Applicant: Patrick Buhl; Normandale Community College  
 Consultant: Bryan Miller; Larson Engineering, Inc.  
 Project: Normandale Community College Parking Lot 6 Improvements  
 Location: 4200 94<sup>th</sup> Street West, Bloomington, MN  
 Applicable Rule(s): 2, 3, 4, and 5  
 Reviewer(s): Dallen Webster and Louise Heffernan; Barr Engineering Co.

### **General Background & Comments**

BUFFER NO. 1

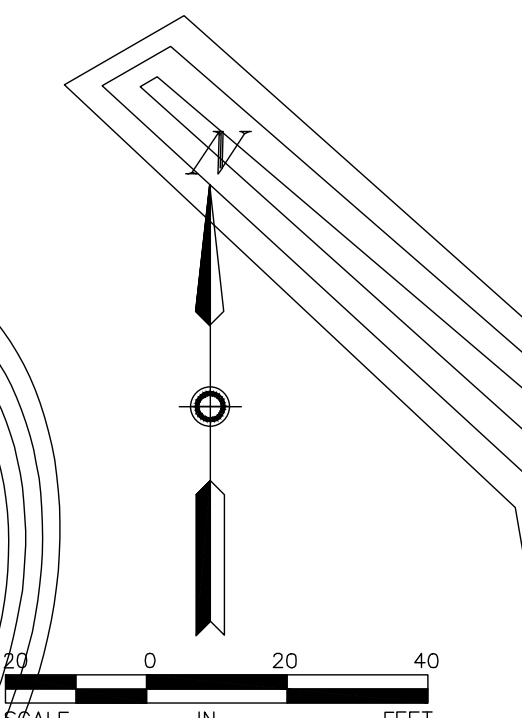
Based on an average 60-foot buffer required along the edge of the wetland downgradient from land-disturbing activities, a 45,366 square foot buffer is required to be provided. As shown on the plans, a 45,422 square foot buffer is proposed. The required minimum buffer width of 30 feet is provided. The project complies with Rule 3.4 criteria.

In accordance with Rule 3.4.5, buffer markers at the edges of the buffer area are required. As shown on the plans, permanent, free-standing markers at the buffer's upland edge are proposed at an interval no more than 200 feet. In accordance with the requirements of Rule 3.4.7, the buffer must be documented by a declaration or other document approved by the district and recorded in the office of the county recorder or registrar before the permit will be issued. The declaration must include an exhibit clearly showing the provided buffer areas and monument locations.

In accordance with Rule 3.4.5, the buffer monumentations with the design and text approved by NMCWD are required at the limits of the wetland buffer on the site.

**FLOODPLAIN  
MITIGATION  
PLAN**

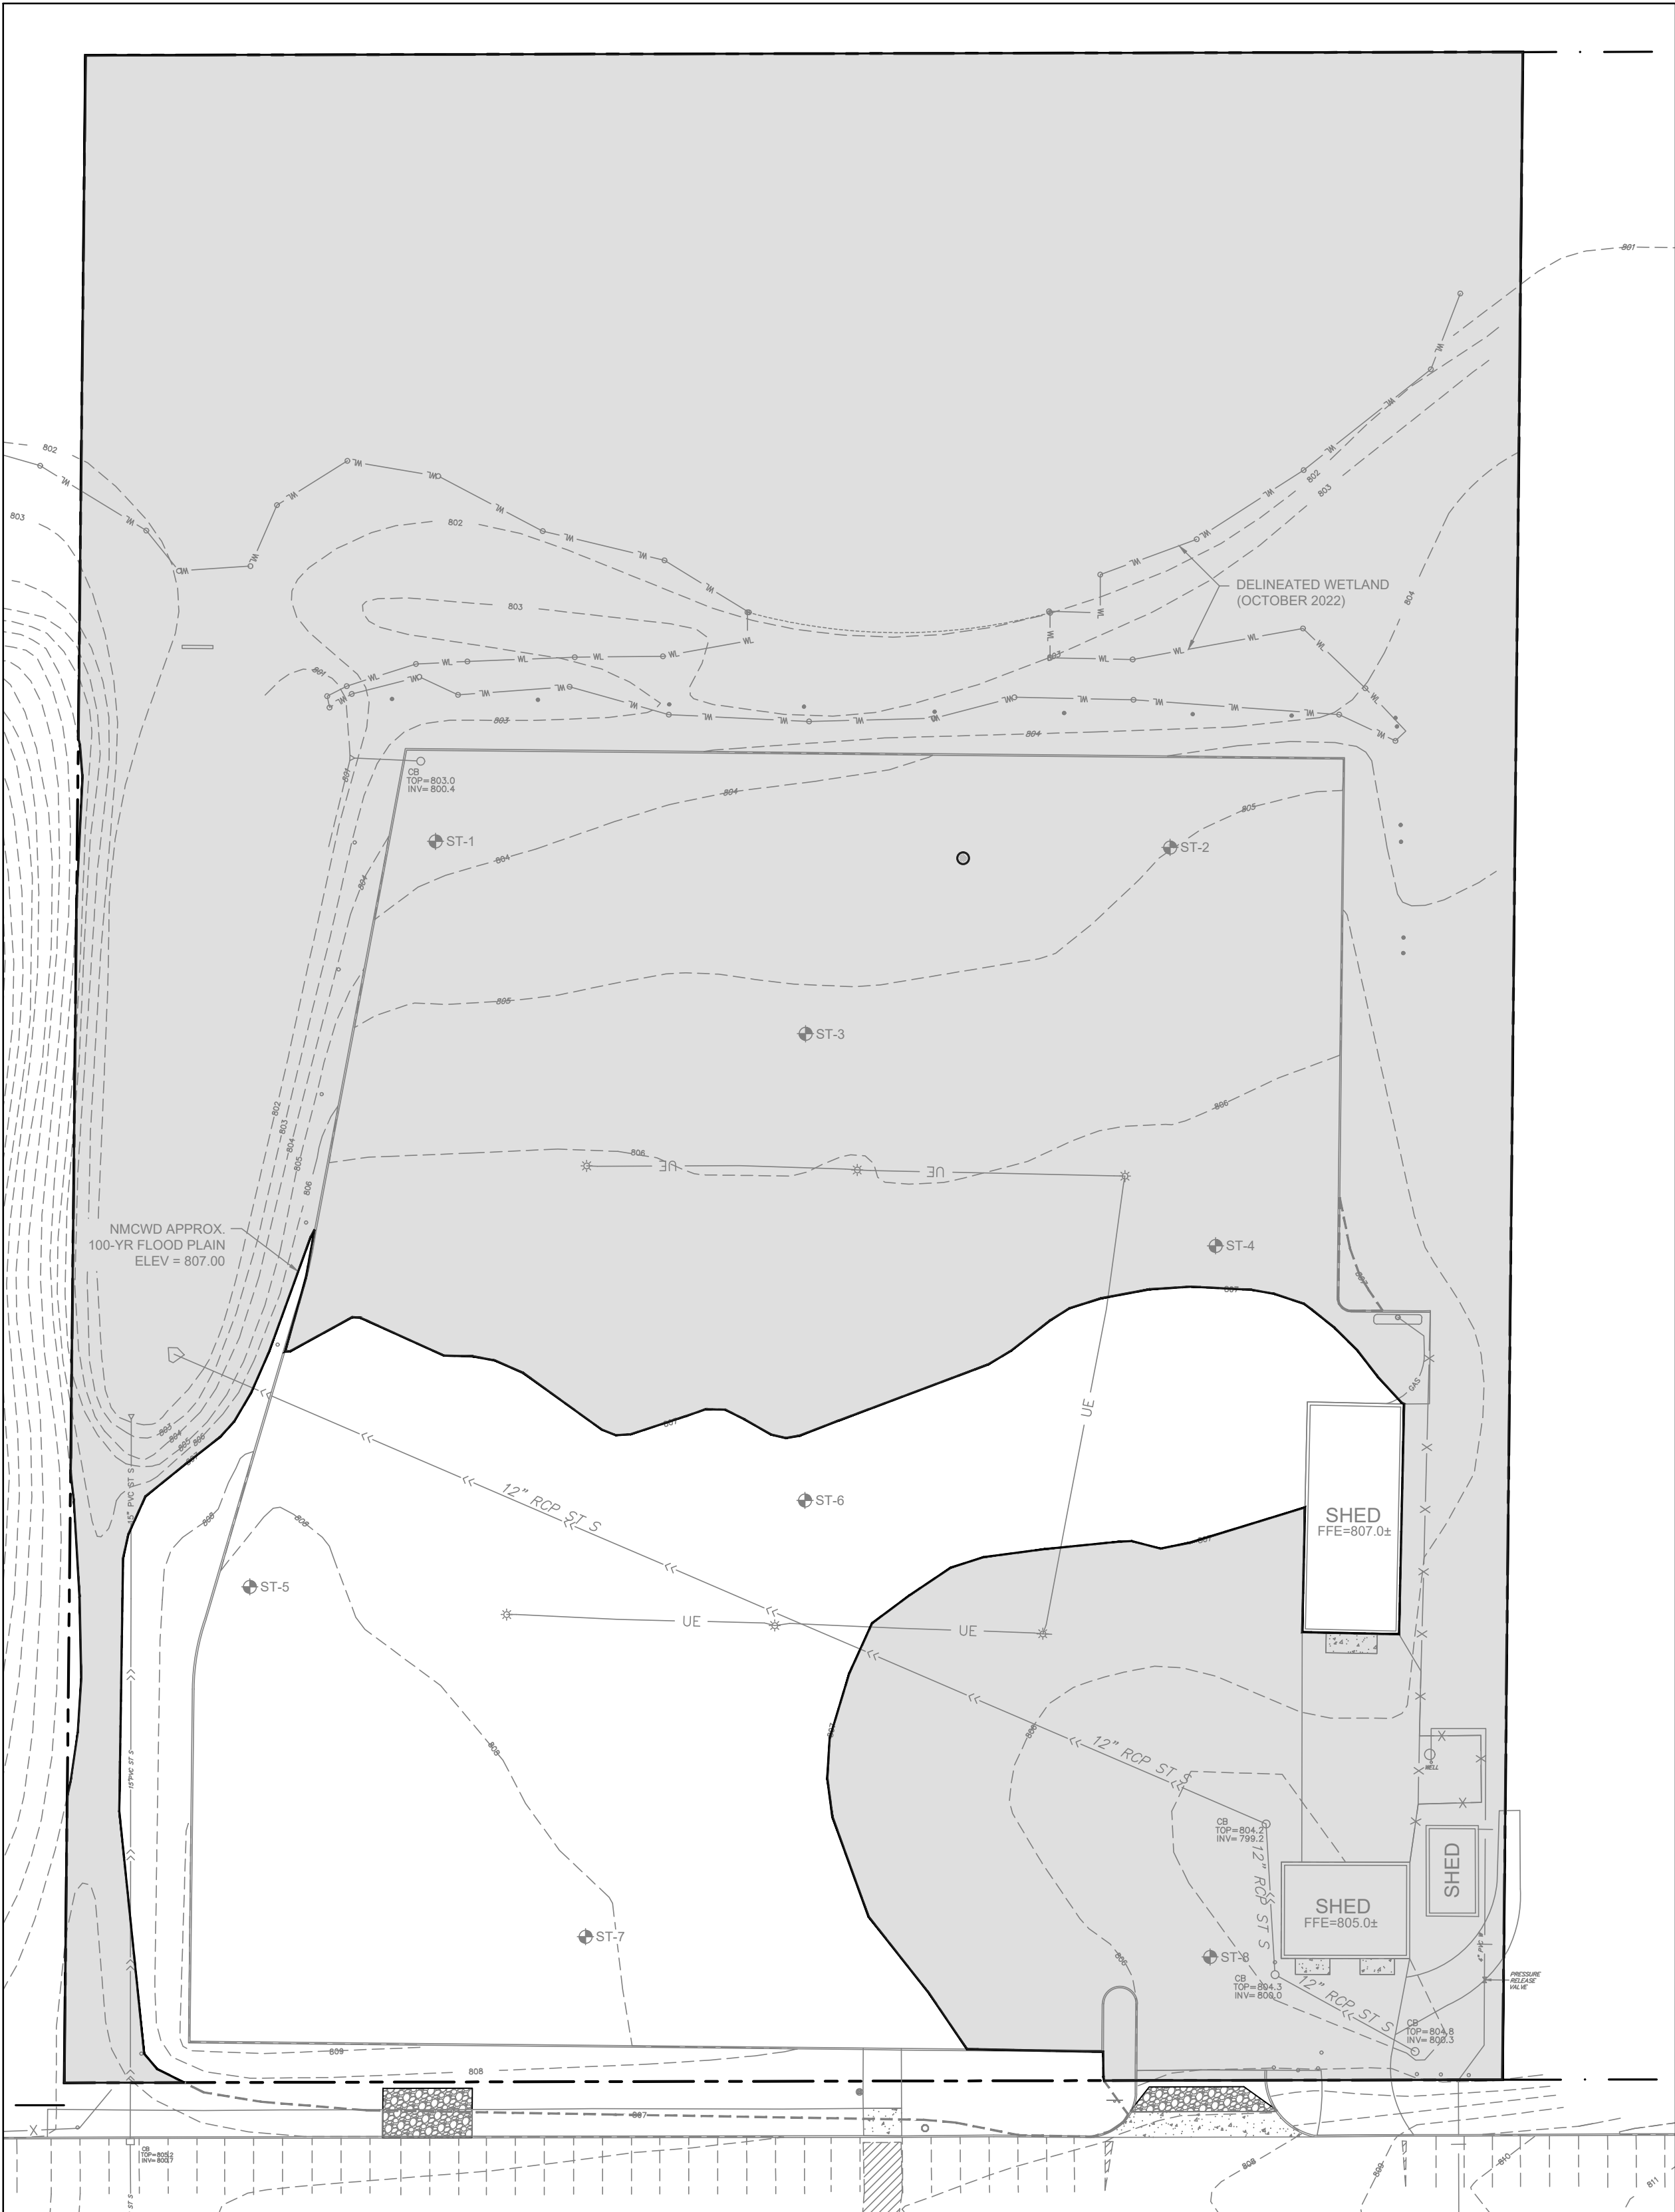
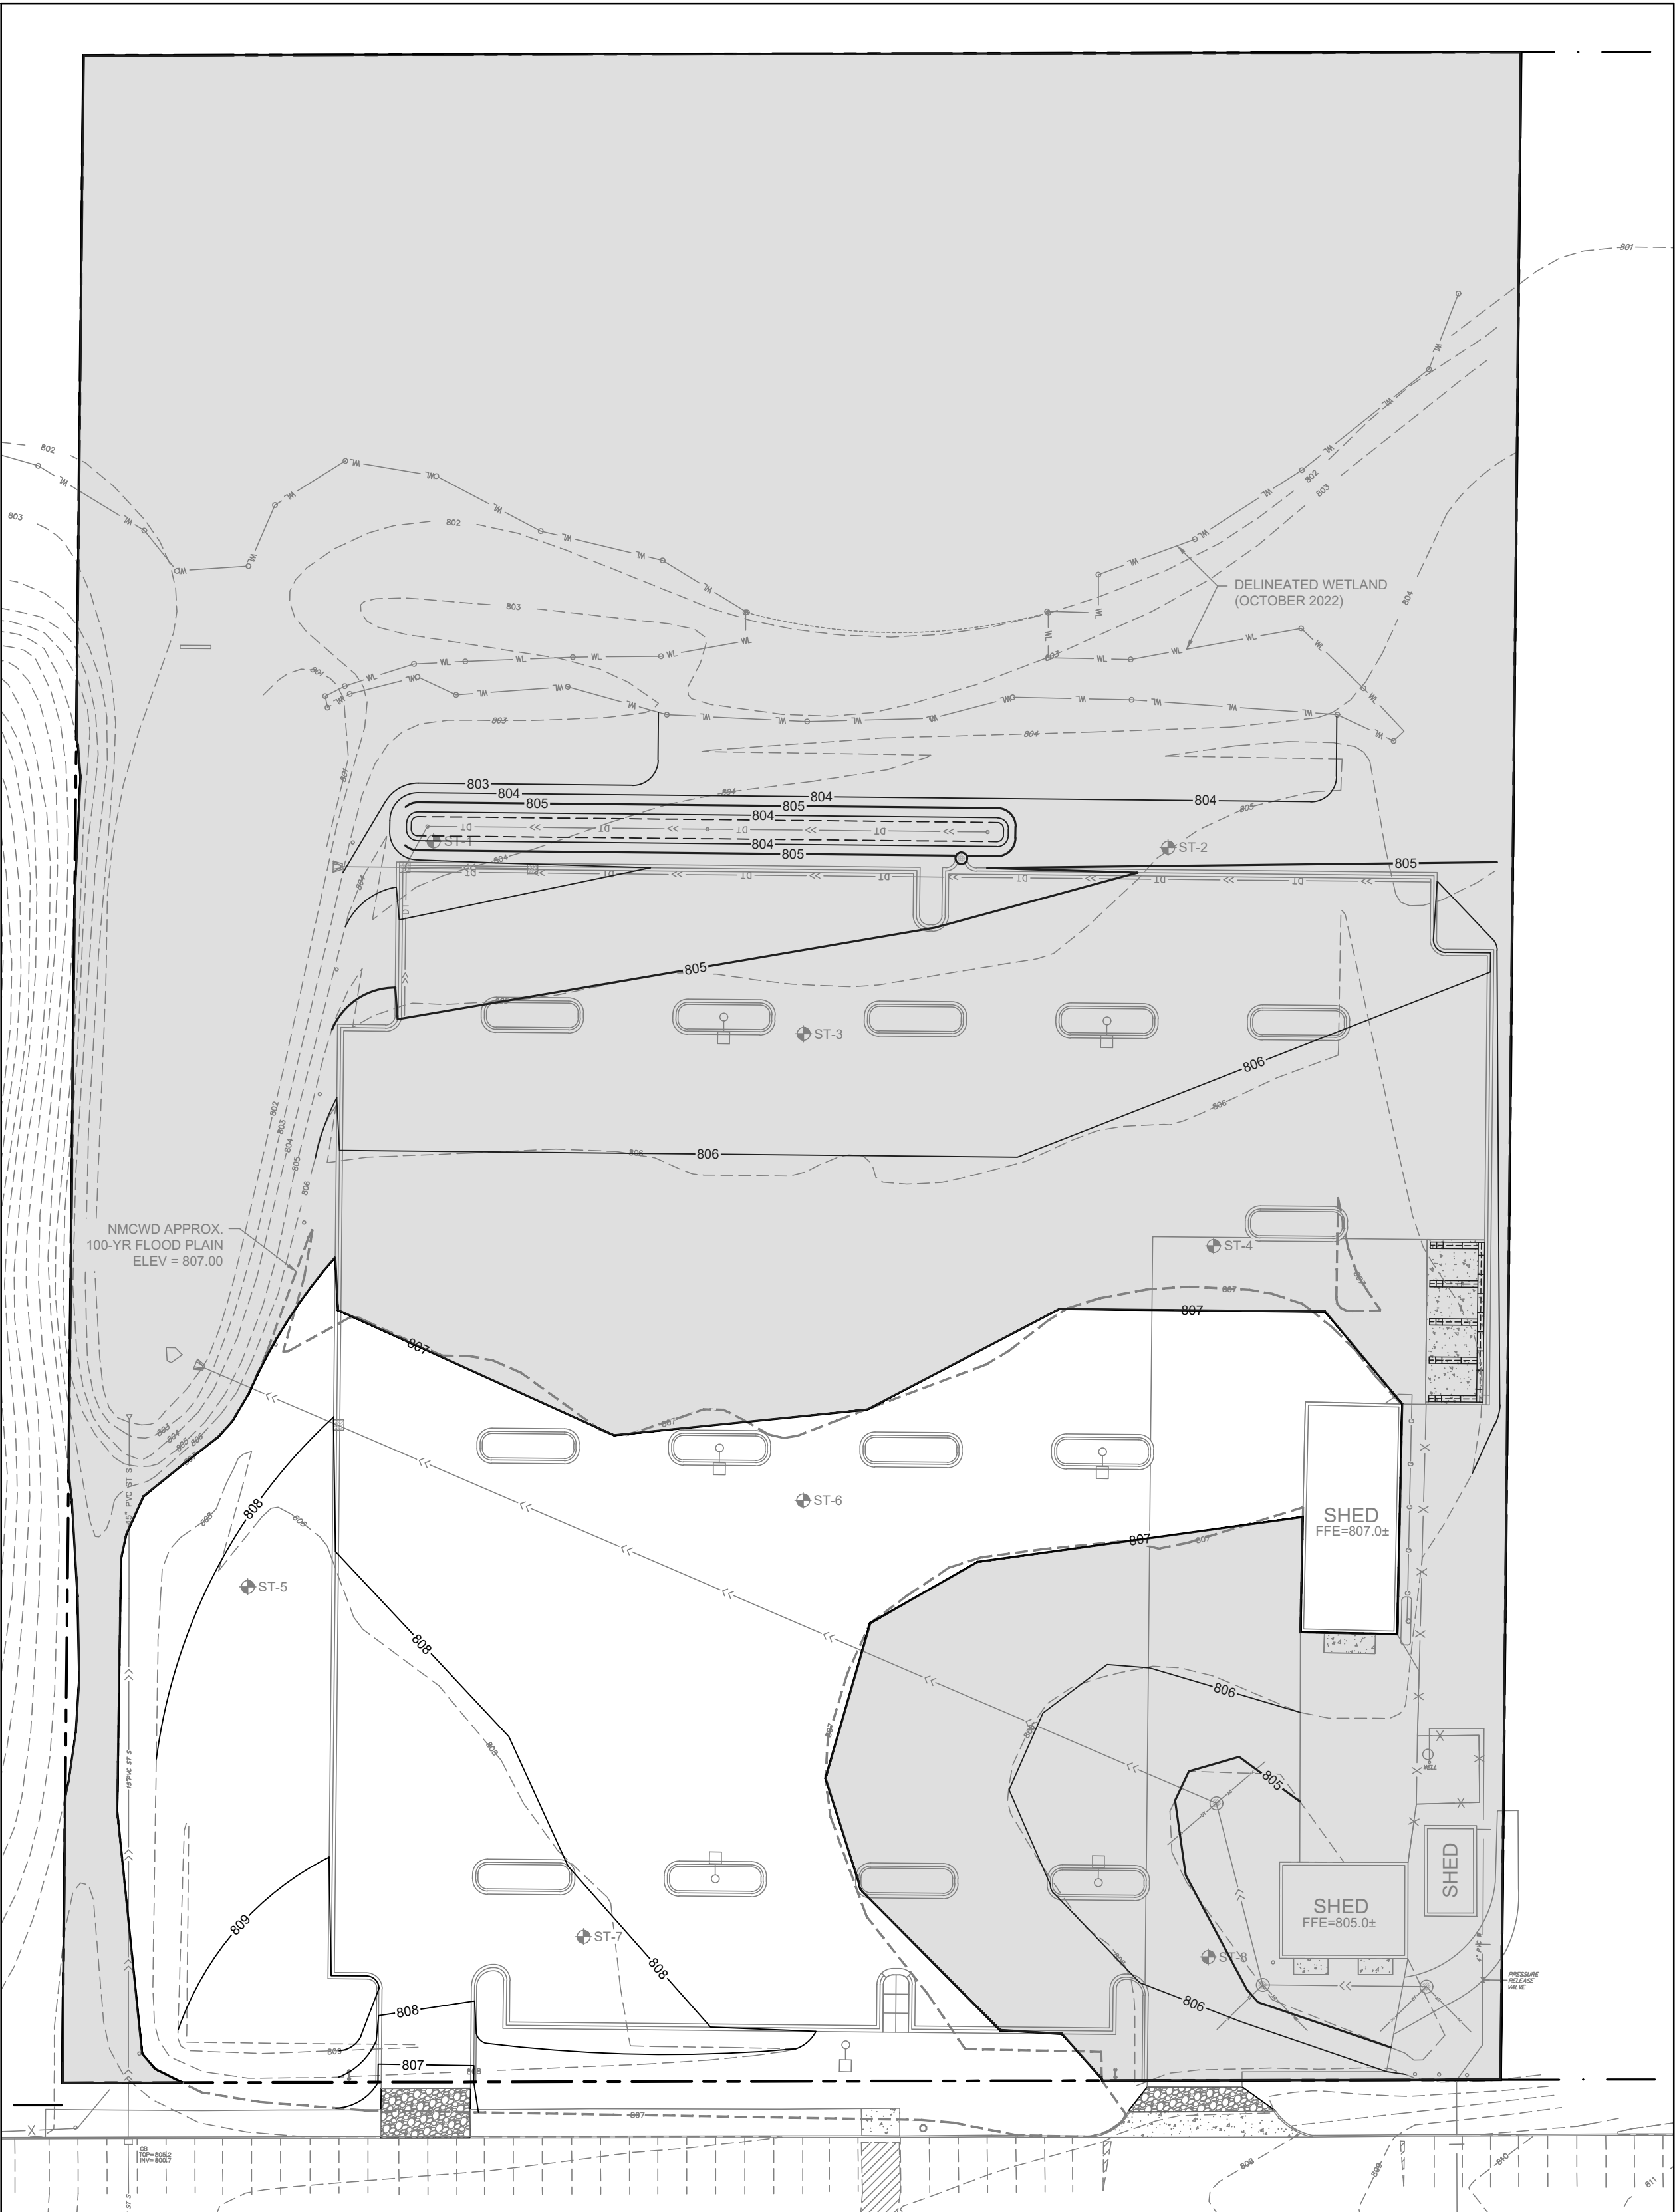
Based on the applicant's submittal, the project will result in an increase of approximately 60 cubic feet of flood storage volume below elevation 807.0 M.S.L., the 100-year frequency flood elevation of Marsh Lake. As shown on the plans, the proposed pavement improvements will generally maintain existing grading and drainage characteristics in post-development conditions. The additional storage volume provided will be at the same elevation +/- 1 foot of fill within the floodplain. The submittal demonstrates and the engineer finds the project is in conformance with subsection 2.3.2 criteria.

The project proposes grading and land-altering activities that will not alter the drainage boundaries within the wetlands' watersheds nor increase the impervious area within the site. As stated in the subsection 2.3.2 analysis, the project will result in an increase in flood storage volume (60 cubic feet) below the 100-year frequency flood elevation of Marsh Lake, thereby not adversely affecting flood risk or transferring flood risk to upstream or downstream landowners, in compliance with subsection 2.3.3 criteria. The submittal demonstrates and the engineer finds that the grading, earthwork, and stormwater facility installation below the 100-year flood frequency elevation of Marsh Lake are not reasonably likely to transfer flood risk to other portions of the site or adjacent landowners.
